ADDENDUM NUMBER 1 BID # 17-37- Main Hall Science Wing Renovation

DOCUMENT 00 91 13
ADDENDUM NUMBER 01

DATE: May 17, 2017
PROJECT: Main Hall Science Wing Reconstruction
PSA PROJECT: 7062
OWNER: Middlesex County College
ARCHITECT: Parette Somjen Architects L.L.C.
TO: Bidders

SK0.1

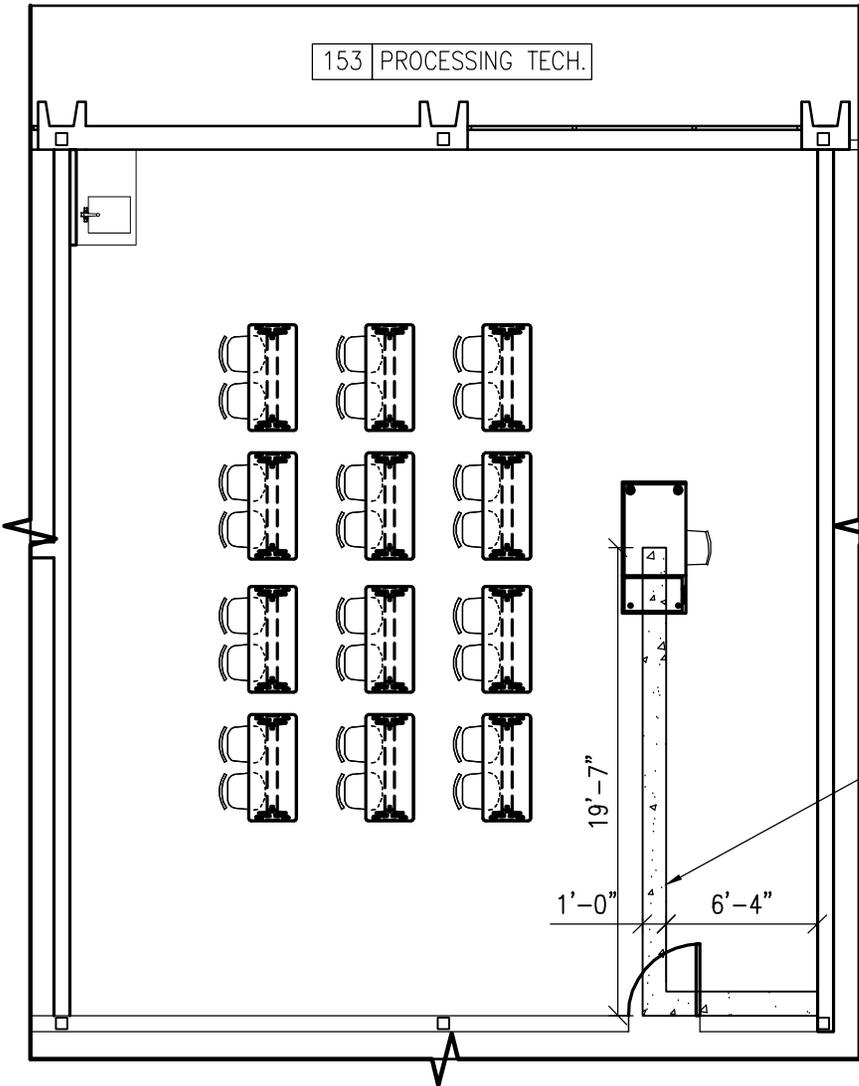
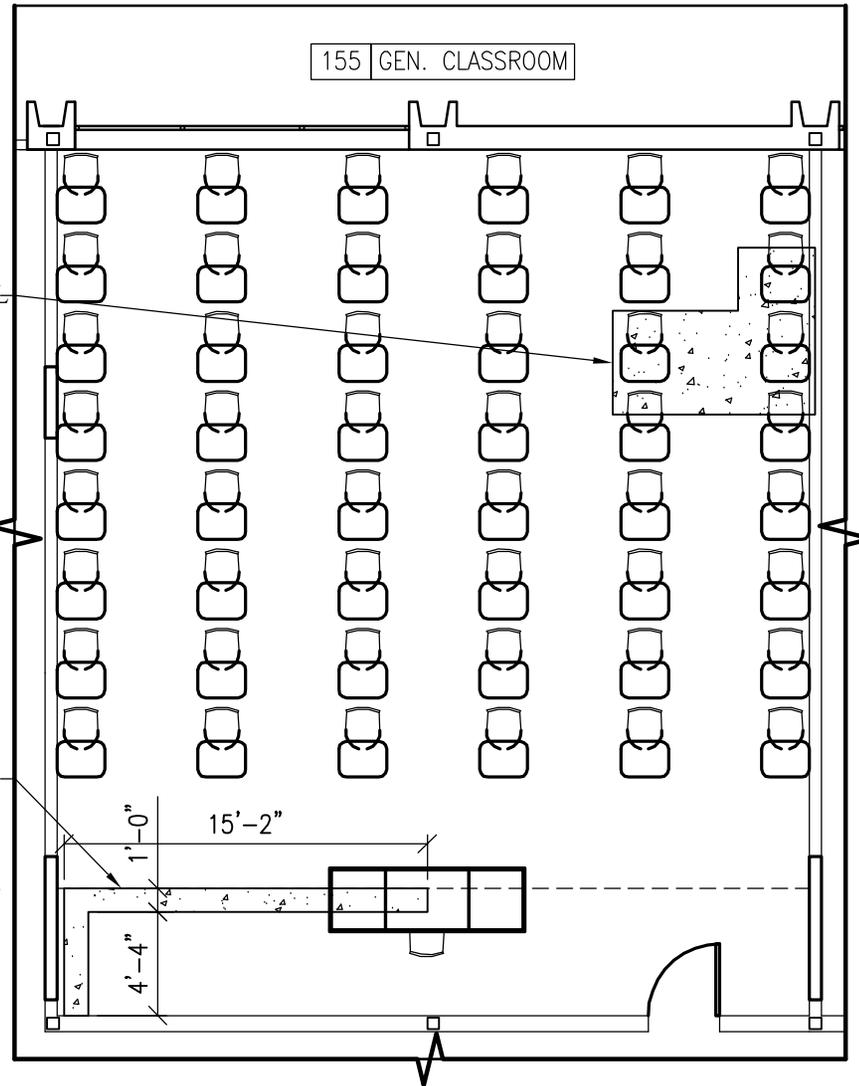
Q.14 Dwg. E-201 shows Floorbox installation (per note # 3) in Room 153 Processing Tech. No floor trenching or cutting is shown on Dwg. A-101 for this room. Please clarify.

A.14 Sketches have been provided, and attached herein, indicating the location and square footage of additional trenching and concrete slab infill in rooms 153 and 155.

HATCH INDICATES AREAS OF SAWCUTTING AND INFILL. REFER TO "SLAB TO EXISTING" DETAIL ON SHEET A6.01 FOR MORE INFORMATION.

SK1.1

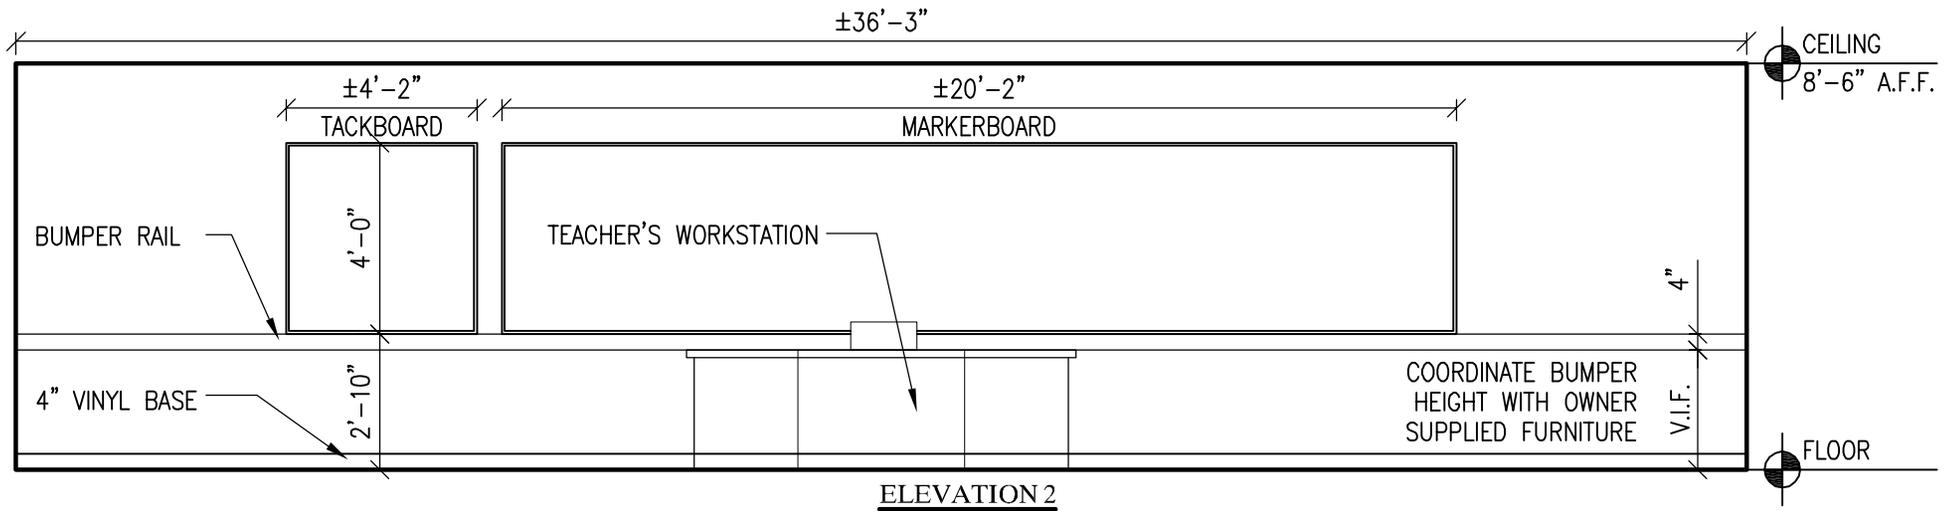
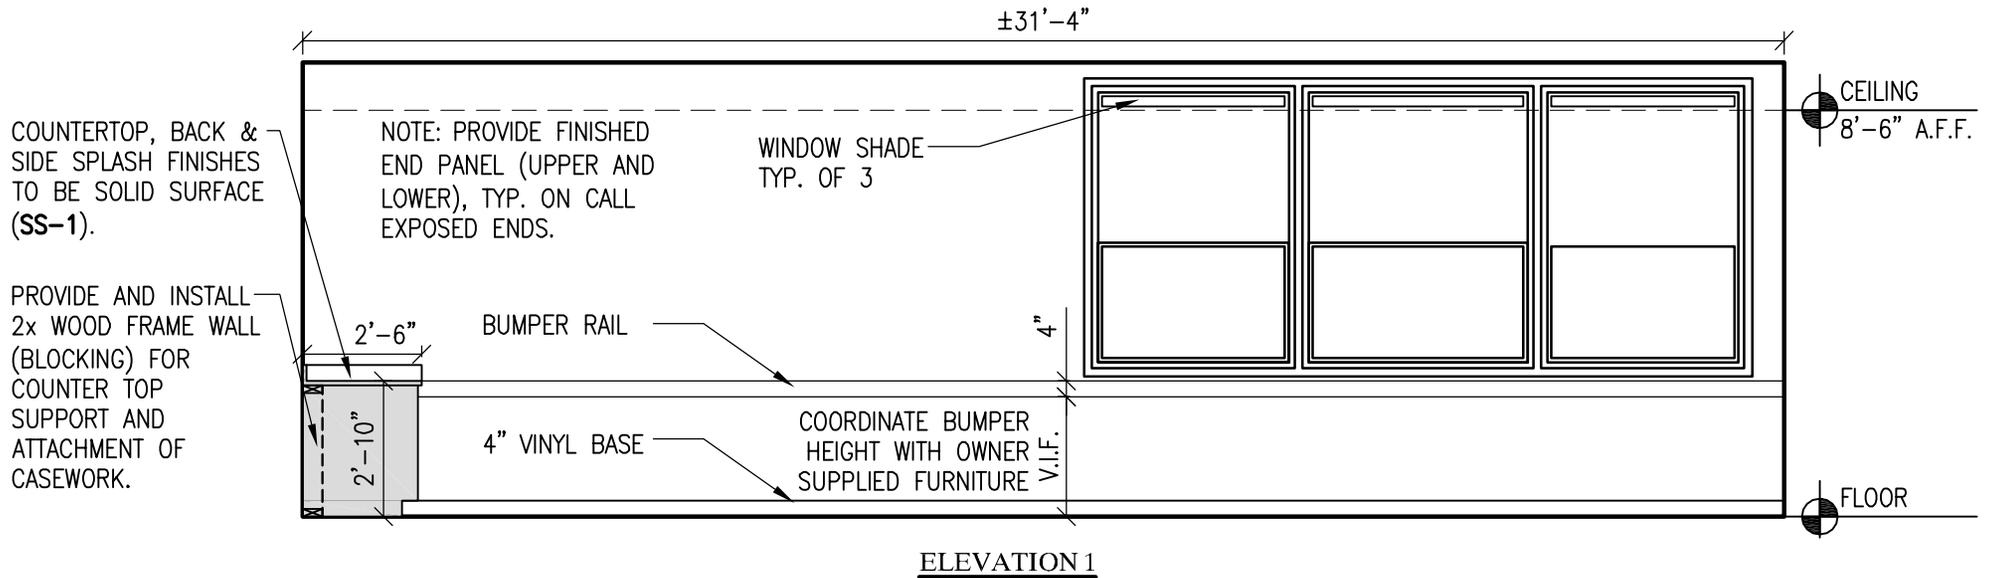
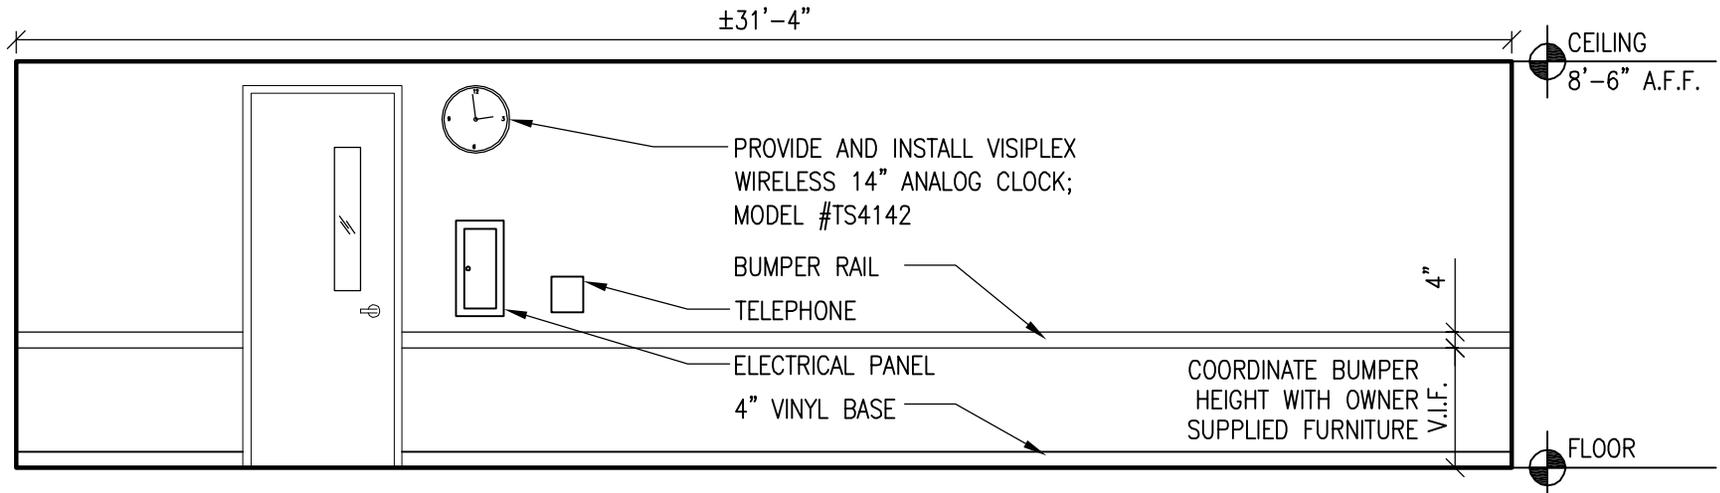
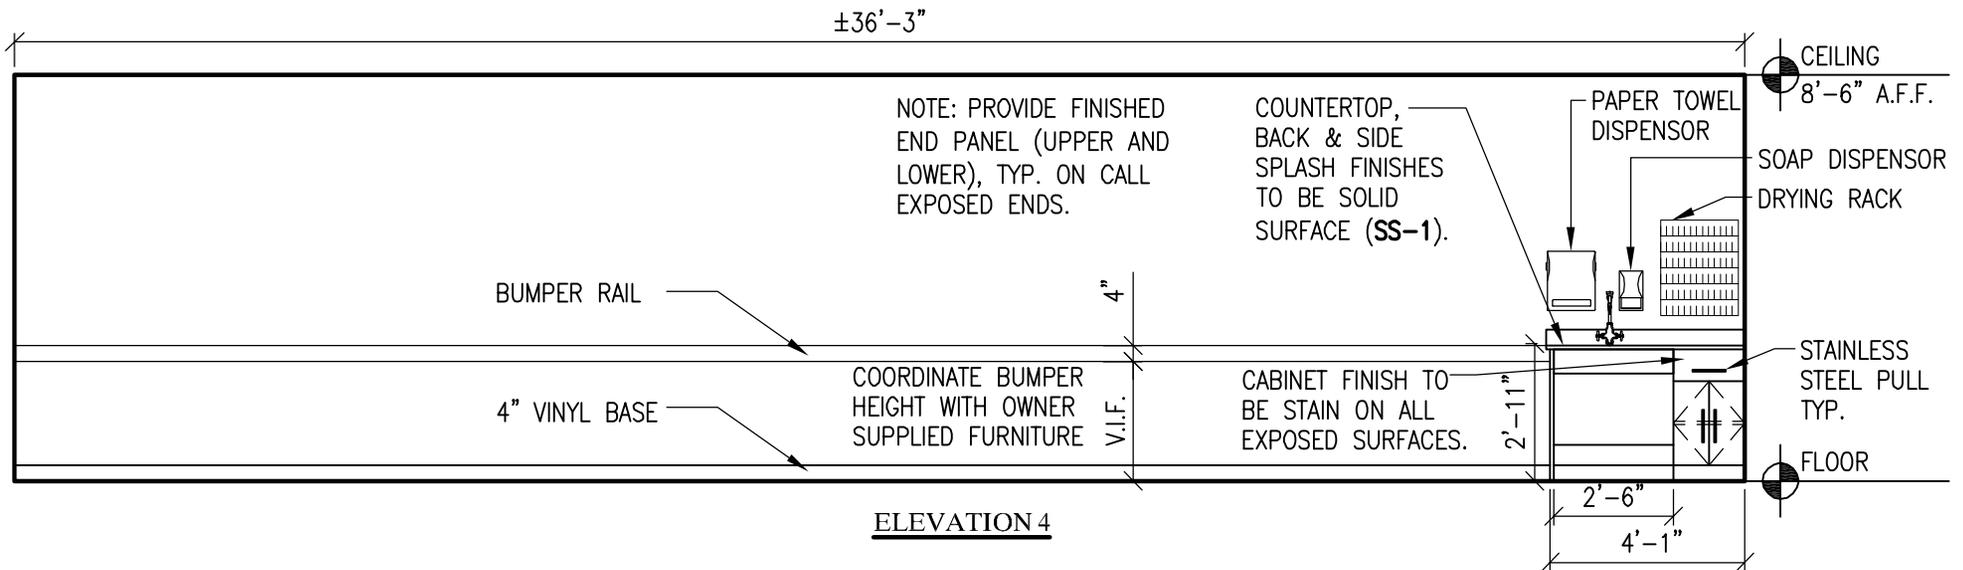
Q.18 Please provide interior elevations for missing walls of Room 153 and all of Room 155.

A.18 Sketches have been provided, and attached herein, refer to 1.3 Attachments for more information.

SK1.3.2

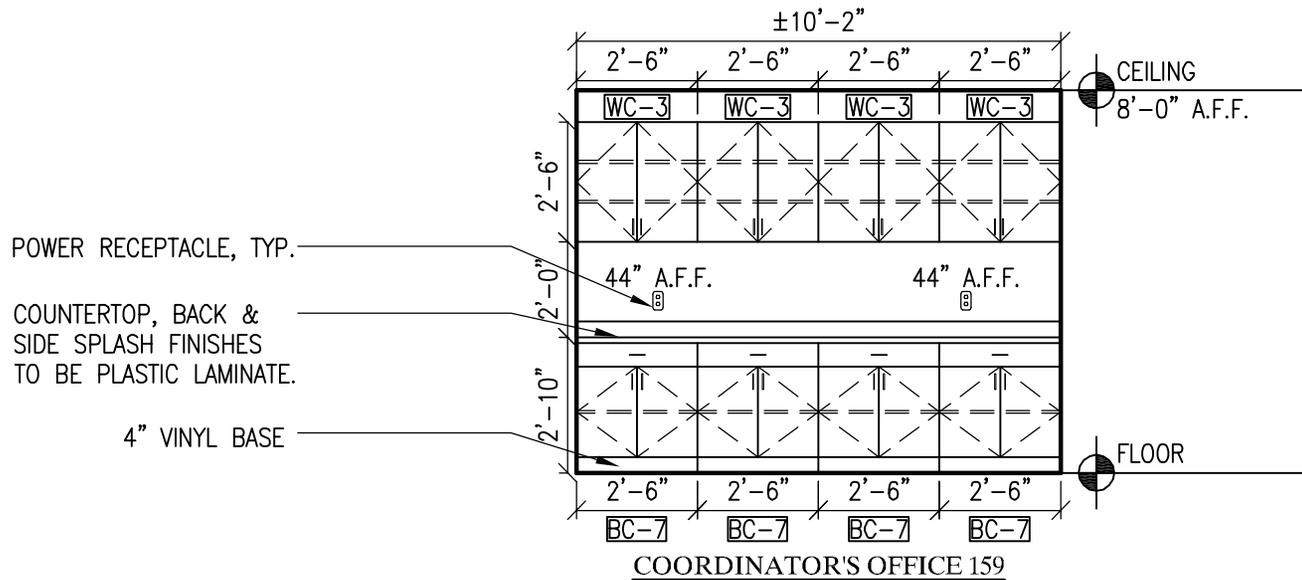
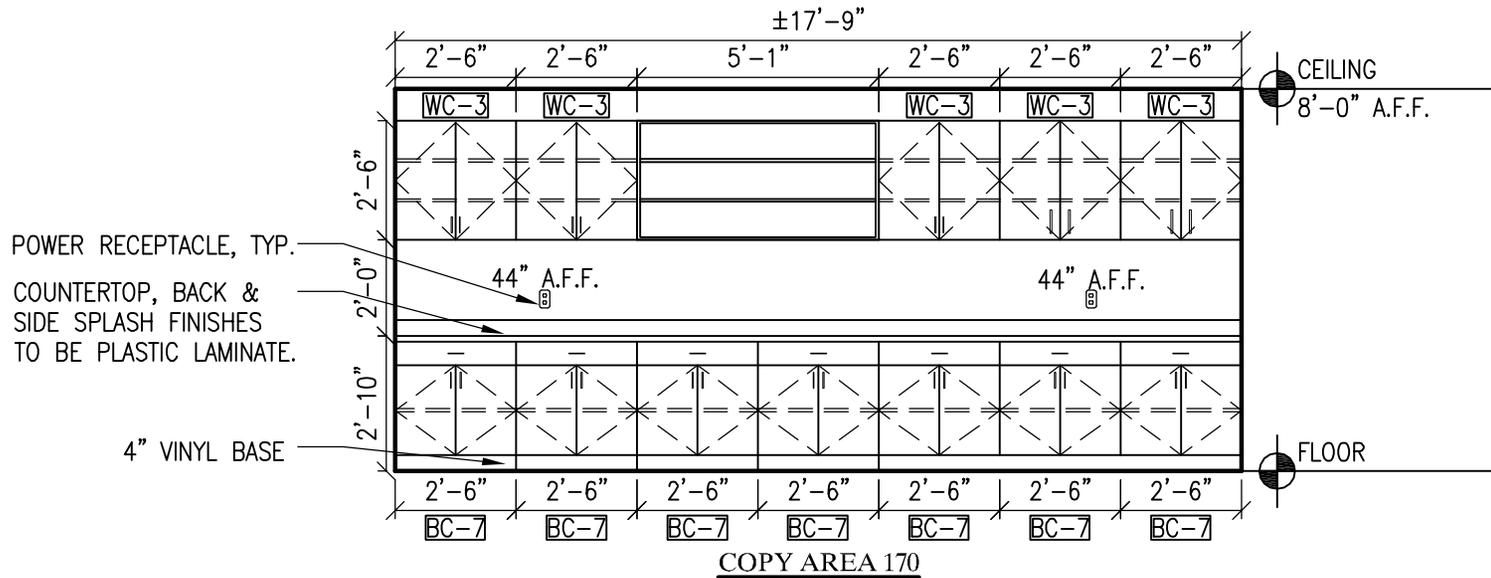
Q.41 Please confirm the casework shown in details 2 & 3/A5.05 are meant for Copy Area 170 and should be supplied under spec 123553.

A.41 The referenced elevations are for Copy Area 170. Sketches have been provided, and attached herein, refer to 1.3 Attachments for more information.

- 1.) COUNTERTOP TO BE TWO LAYER 3/4" MDF BOARD WITH PLASTIC LAMINATE FINISHED SURFACES. BACK AND SIDE SPLASHES TO BE ONE LAYER 3/4" MDF BOARD WITH PLASTIC LAMINATE FINISHES.
- 2.) BC-7 HAS BEEN ADDED AS ADDITIONAL CASEWORK. BC-7 IS CAMPBELL RHEA MODEL #3685C.
- 3.) REFER TO CASEWORK SCHEDULE FOR WC-3 INFORMATION.
